MARKSHEFFEL BUSINESS CENTER FILING NO. 1

PPR2627

MARKSHEFFEL BUSINESS CENTER
7720 VENTRUE STREET
COLORADO SPRINGS, CO 80951

1 of 1
SITE PLAN

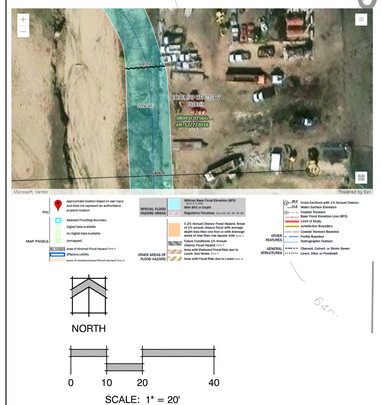
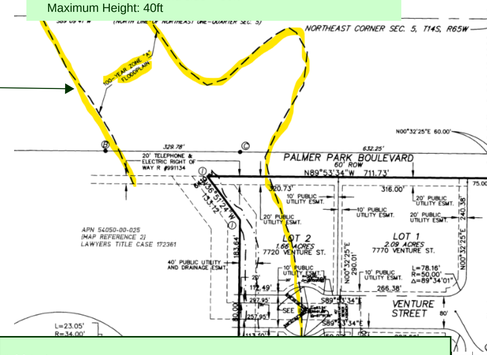
Please update to reflect current site.

Please identify the floodplain linetype a little more clearly as it blends in with the other lines.

This line appears to be the 100-yr floodplain, but is not clearly labeled. Please update.

Please label.

The existing drainage easement does not appear to be sufficient for channel improvements. Please provide an additional non-exclusive permanent drainage easement as a part of this application to allow the County and/or other entities to be able to complete channel improvements in the future. Please address additional easement in the drainage letter. Recorded easement shall be uploaded into EDARP prior to the approval of this application.

Please make the storage area a little more prominent on the SDP, maybe add it here as well even if it is the same as the 41,772 SF

Please label.

A Joint access easement and maintenance agreement is required as the proposed access of Lot 2 is through Lot 1. Although the lots are under the same ownership and used together, Lot 1 could still be sold in the future and Lot 2 would no longer have legal access here.

Please identify all fencing height and opacity.

Please label. This extends into the ROW. Please verify with DPW if this is permitted and/or if a License Agreement is needed.

Please include Label: Local 80' ROW

Corresponding note added to the drainage letter. Please contact the regional floodplain administrator, Keith Curtis, regarding this application as the FEMA mapping shows the floodplain outside of the defined channel. Please ask him how to document this in the drainage report and how the FEMA map vs. contour-based floodplain limits should be shown on the SDP and whether there needs to be any clarifying notes in the SDP or drainage letter. Please include any relevant documentation from Keith Curtis in the next submittal.

Please add to your summary table:
Current owner w/ contact info.
Business name.
Parcel Number/Tax ID
Zoning District: I-3, CAD-O
Setbacks: front, rear, and side = 30ft
Maximum Height: 40ft

Add Notes:
This Site Development Plan is for Outside Storage associated with the adjacent business (*enter name)* located on Lot 1 of Marksheffel Business Center Fil. No. 1. The associated Site Development Plan approval is PCD File No. PPR05010.

Please review Falcon Fire Protection District's EDARP comment. Provide internal access road/route turning radius verification. I think this would be best addressed with a "Page 2" that shows the access path from Venture St, through Lot 1, and then within Lot 2.

503.2.4 Turning radius. The required turning radius of a fire apparatus access road shall be determined by the *fire code official*. *33' inside and 53' outside radius. Resubmit the site plan showing the turning radius.*
